MEMO

To: Kristopher Byrd, Well Construction and Compliance Section Manager
From: Travis Kelly, Well Construction Compliance Coordinator
Subject: Review of Water Right Application G-19045
Date: February 16, 2022

Application # G- 19045

TO: Water Rights Section Date 2/1/2022
 FROM: Groundwater Section Stacey Garrison/Travis Brown
 Reviewer's Name
 SUBJECT: Application G- 19045 Supersedes review of _____
 Date of Review(s) _____

Water-Level Measurements-CLAC 10479

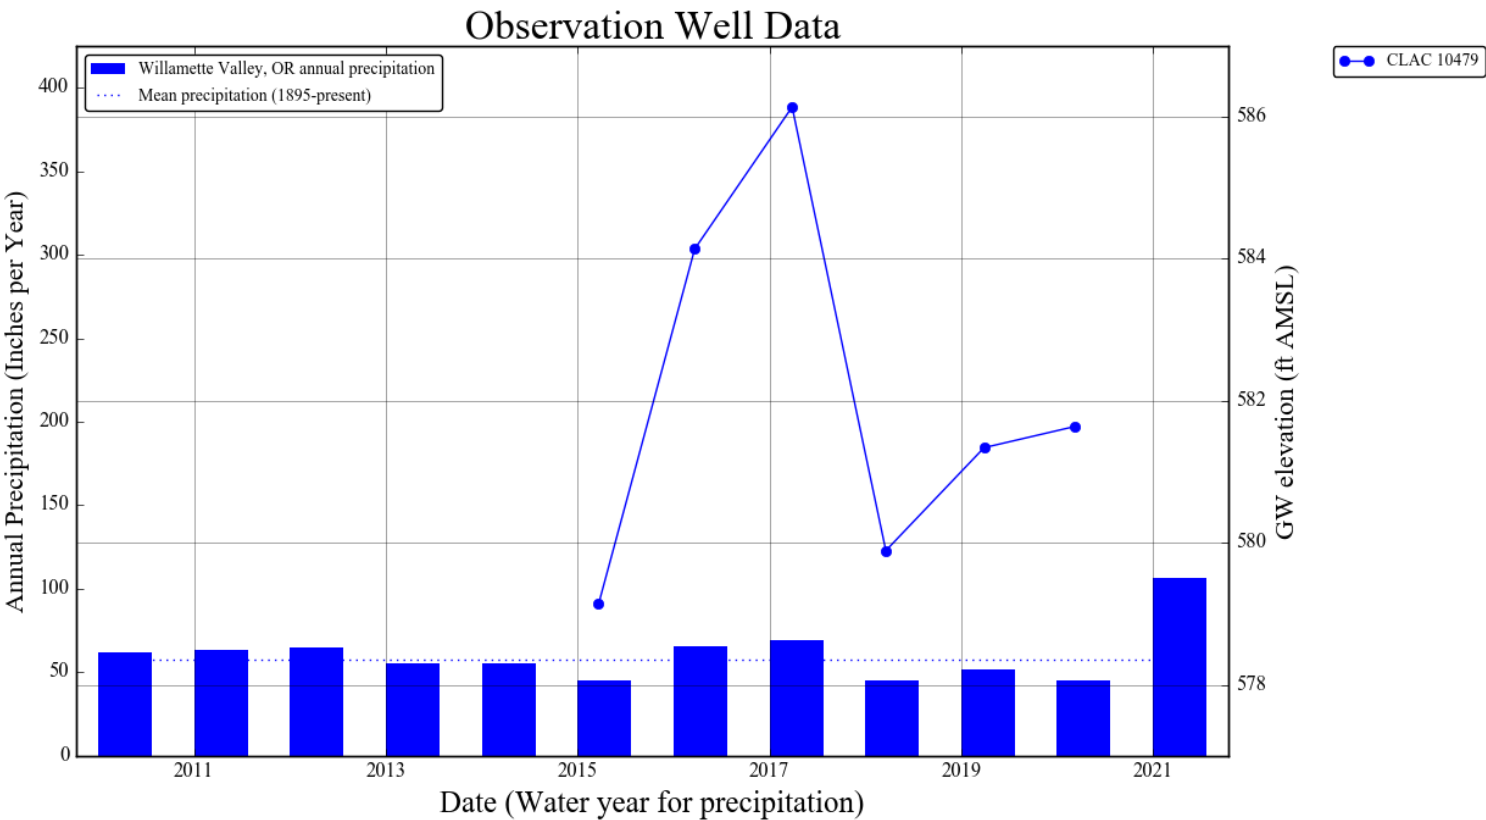
A review of statistics for nearby well records was completed and compared with the proposed rate of 0.545 cfs (244.6 gpm) for this application (see Well Statistics 5S/2E-22). There is some uncertainty regarding the ability of the groundwater resource to sustain the proposed use of 0.545 cfs (244.6 gpm); median reported well yield is 20 gpm, and the proposed rate is more than the maximum reported yield of 150 gpm. The proposed rate for this application is 1,223% of the median and 163% of the maximum reported yield. Previous studies have reported yields for wells using the Willamette aquifer ranging from 64 to 980 gpm, however the higher reported yields are likely utilizing unconsolidated and/or gravel water-bearing zones (Woodward et al 1998). Water level trends for nearby wells that utilize alluvial aquifers appear to be stable (see Water Level Measurements in Nearby Wells). CLAC 10479 is 585 ft to the southeast of the POAs, and shows a steady water level trend over the 5 year record but a steep decline of 6 feet between March 2017 and March 2018. CLAC 154, CLAC 9966, CLAC 10285, CLAC 17723, CLAC 20017, CLAC 20566, CLAC 51358, CLAC 54578, CLAC 64005, and CLAC 64205 are between 2 and 4.6 miles to the northwest of the POAs; these all show relatively stable trends, except CLAC 17723 which shows a decline but has only two datapoints. CLAC 9923, CLAC 9933, CLAC 18908, and CLAC 52063 are between 2.9 and 3.9 miles to the north of the POA; these all show stable trends. CLAC 55698 is 2.3 miles to the northeast of the POAs, and shows a stable water level trend. While the wells do not show persistent or widespread declines, the data is limited through the present day, only one of these wells (CLAC 10479) is within a mile and this well did experience a decline of 6 ft within a year in the last five years.

Wells Statistics

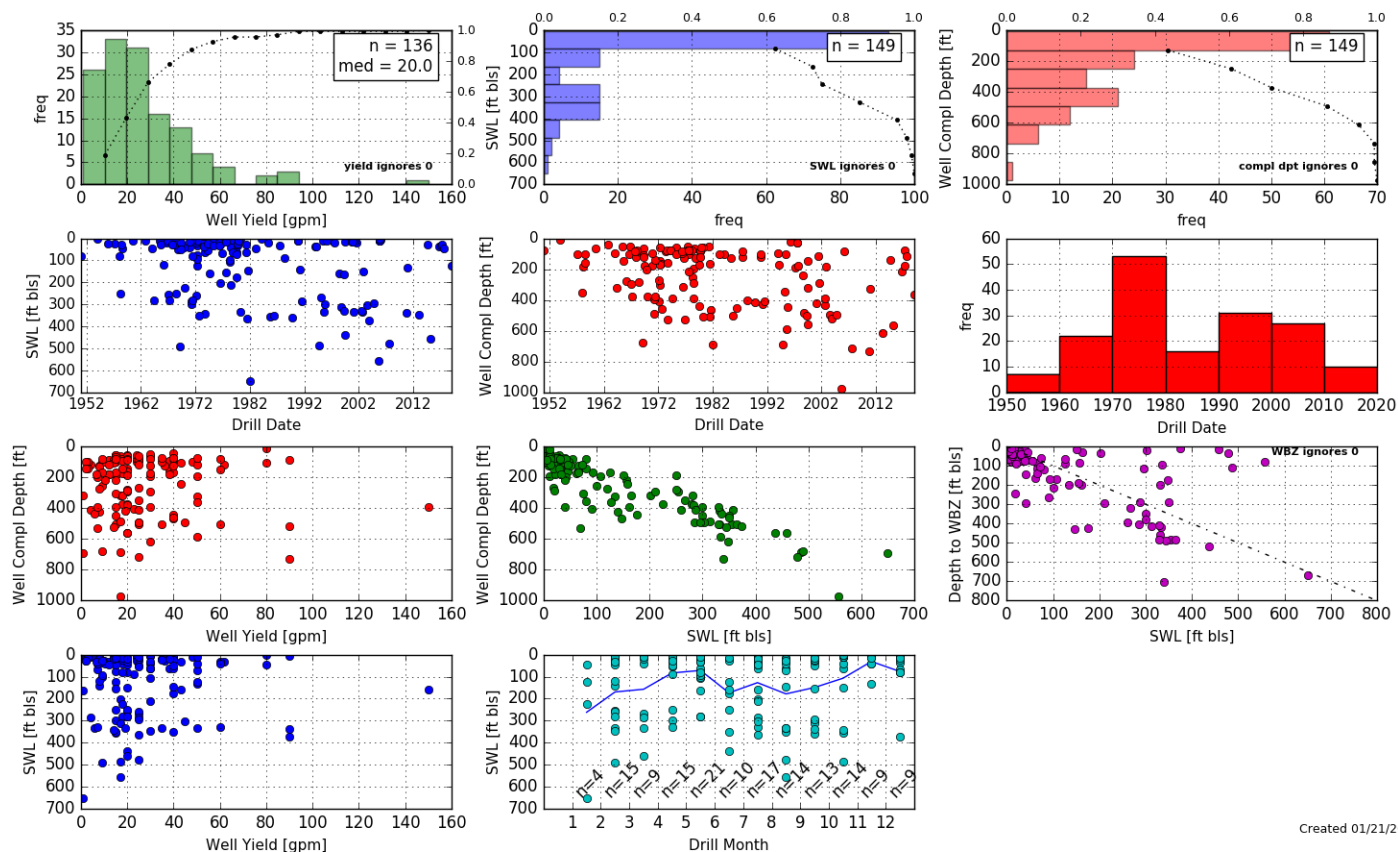
Due to the potentially limited extent of water-bearing sandstone in the subject aquifer, and based on the nearby well statistics, it is unlikely that the applicant will be able to obtain the requested maximum rate of 244.6 gpm (0.545 cfs) from the two proposed POAs. It is likely that the requested maximum rate would exceed the capacity of the groundwater resource. If a permit is issued for this application, the conditions in B1(d)(i) and B2(c) are recommended to protect senior users and the groundwater resource.

Theis Drawdown Analysis-Well 1

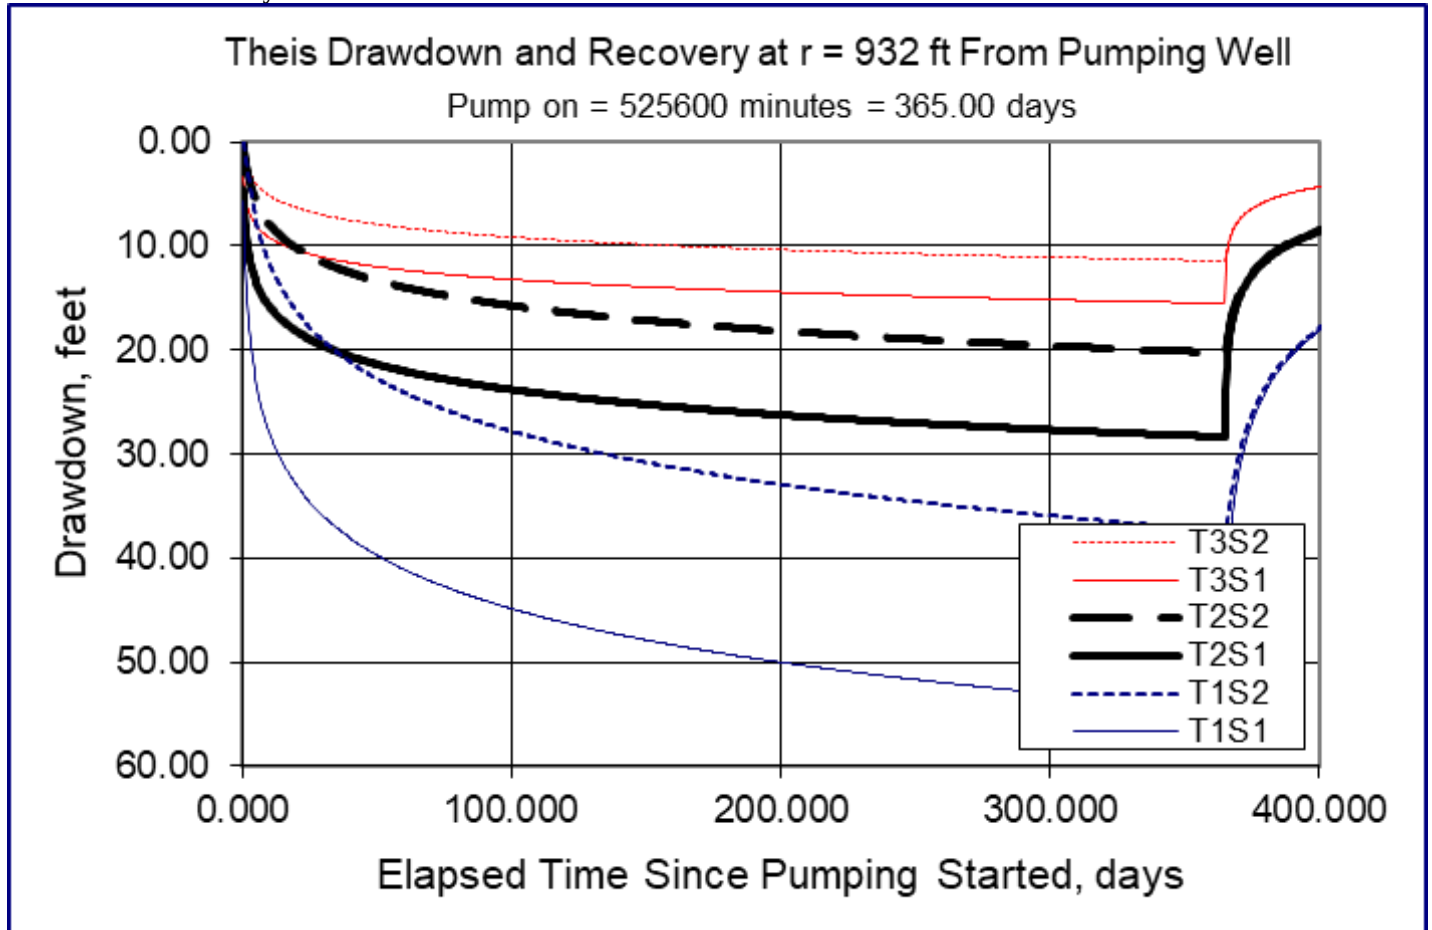
The nearest groundwater user (CLAC 10479, a POA on permit G17174 with priority date of 5/13/2013) is located approximately 585 ft south of Well 1, and 932 ft southeast of the proposed location for Well 2, and at an elevation of 596 ft. CLAC 10479 is completed to a depth of 125 ft bls with a perforated casing from 50 to 108 ft bls (488 to 546 ft msl). The seal of Well 1 (CLAC 56770) extends to 561 ft msl, but due to the seemingly discontinuous nature of the water-bearing sandstones and claystones, it is difficult to determine whether Well 1 is sealing through the water-bearing zone that CLAC 10479 is utilizing. It is likely the proposed use would cause some degree of well-to-well interference with CLAC 10479, however due to a lack of high quality data for this area with which to estimate hydraulic properties of the aquifer, it is difficult to anticipate how much the proposed use may interfere with nearby groundwater rights. To assess the degree of drawdown, a Theis drawdown analysis was conducted for the proposed use (see attached Theis Drawdown Analysis-Well 1, and -Well 2). Results indicate that the proposed use is not likely to cause well-to-well interference with CLAC 10479 that exceeds the threshold under the standard condition for alluvial aquifers in the Willamette Basin. There is insufficient evidence to conclude that the proposed use would likely result in injury to prior groundwater rights.
